REVIEW

Chapter 5 - Environmental Impacts of Plant Operation
(Specifically 5.3 and 5.5)

Draft Environmental Statement

NEP 1 & 2

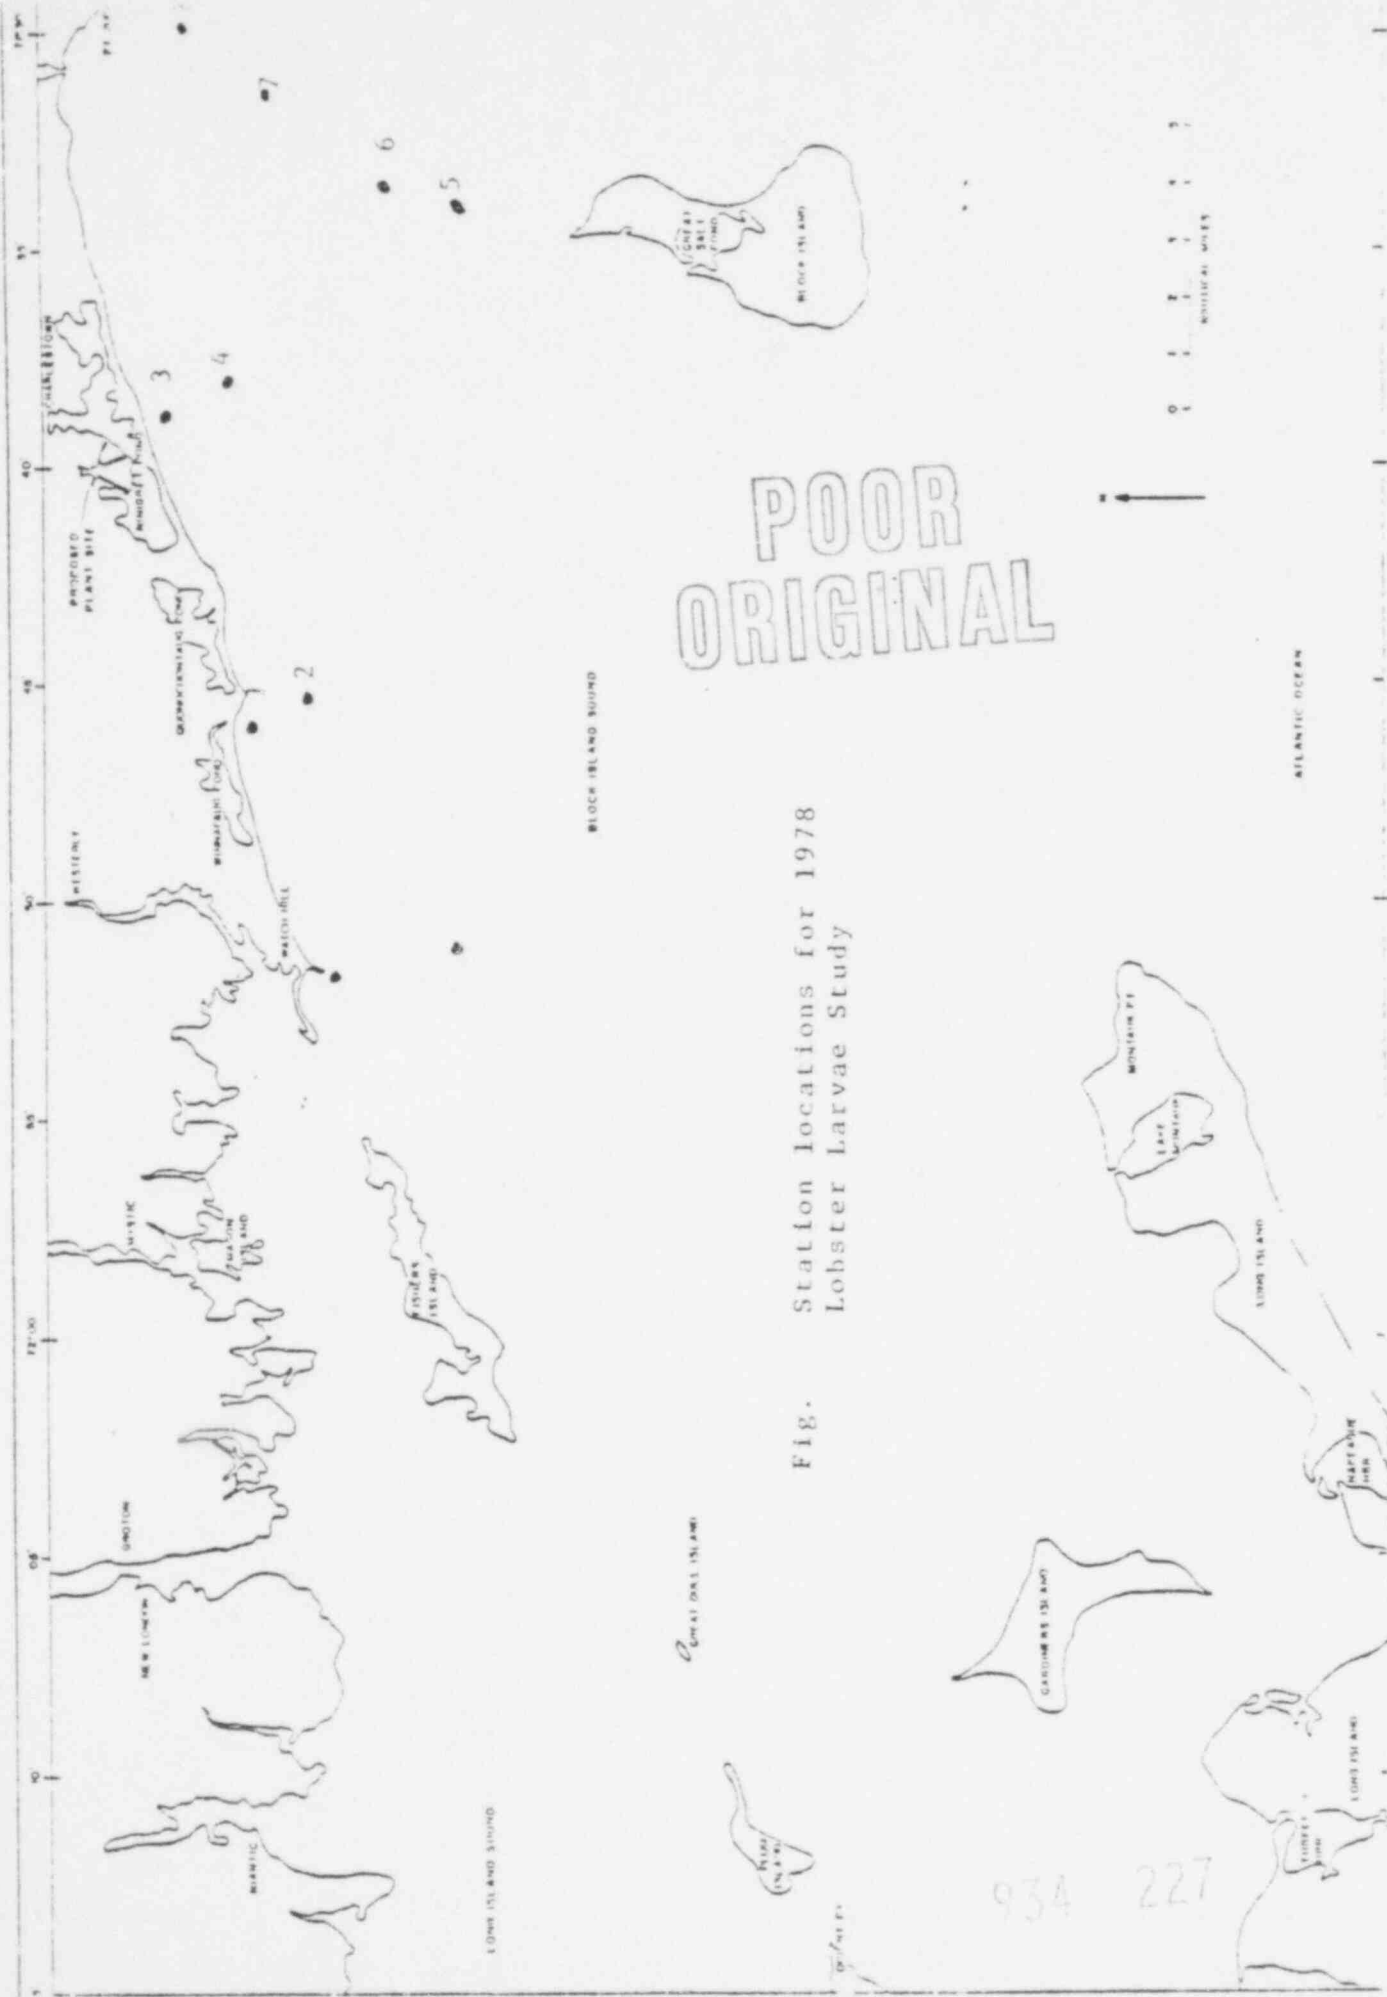
During the period May-September, 1978, surface drifters were released regularly at eight (8) sites (see figure) in Block Island Sound by University of Rhode Island (URI) and R. I. Department of Environmental Management (RIDEM) personnel. Releases were made on fifteen (15) dates, on approximately a weekly basis. Each release totaled 200 drifters, twenty-five at each of the eight stations. Drifter returns were quite high overall. Of the 3000 surface drifters released during the fifteen week period, 1475 were returned for an overall return rate of 49%.

The results of the program showed that drifters released at the nearshore stations, especially stations #1, 3, 4 and 8 came ashore so rapidly that the release sites were inadequate for measuring long term surface drift along the south coast of Rhode Island. Station #3 was in 30 feet of water off Charlestown at the approximate location of the intake structures, and station #4 was one mile further offshore. The URI report warned that "It was found that release sites close to shore yielded information that was strongly biased by very short term tidal currents and wind. Without looking closely at time-of-retrieval of the drifters, implications about nearshore drift might be erroneously made." Tabular data from the URI survey for Station #3 are included as an appendix to this critique.
